MODEL  
2017-2018MY  
Cadenza (YG)

NUMBER  
188

SUBJECT: SERVICE ACTION: ELECTRIC THERMOSTAT  
ASSEMBLY REPLACEMENT (SA346)

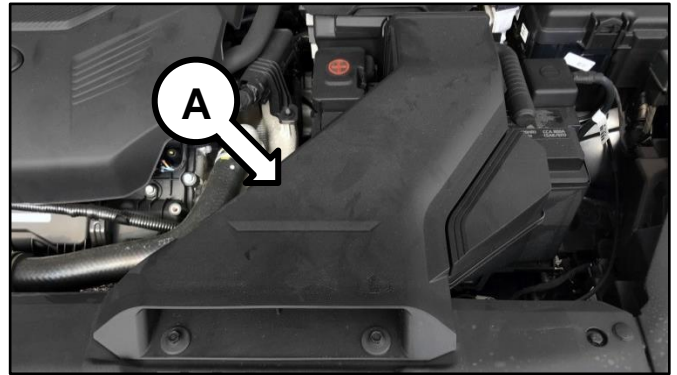
1. Allow the engine to cool down then remove the air duct (A).

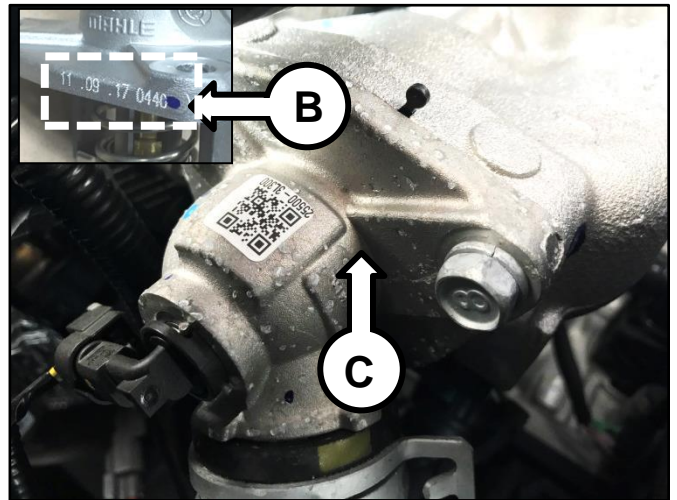
2. **IMPORTANT:** Ensure the new ECT assembly (B) has a LOT number dated July 20, 2017 (07/20/2017) or later. If the LOT number is dated earlier or does not exist, have your Parts Dept. contact Parts Help Desk at (800) 542-5611 or via Parts Portal on WebDCS.

Replace the ECT assembly (C) by referring to the “Engine Mechanical System → Cooling System → Electric Thermostat (ECT) → Repair procedures” chapter in the applicable Shop Manual on KGIS. **NOTE: be careful not the damage the original gasket as it will be reused with the new ECT.**

**Tightening Torque for ECT bolts:**  
12.3 – 14.5 lb.ft (16.7 – 19.6N.m,  
1.7 – 2.0 kgf.m)

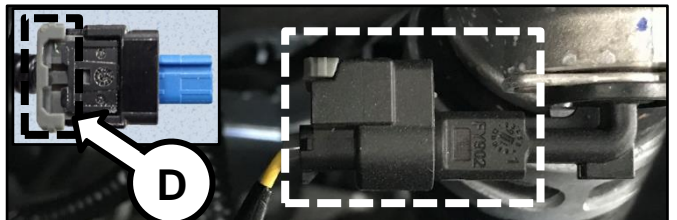
Ensure the connector lock (D) is fully disengaged to properly disconnect the ECT connector.
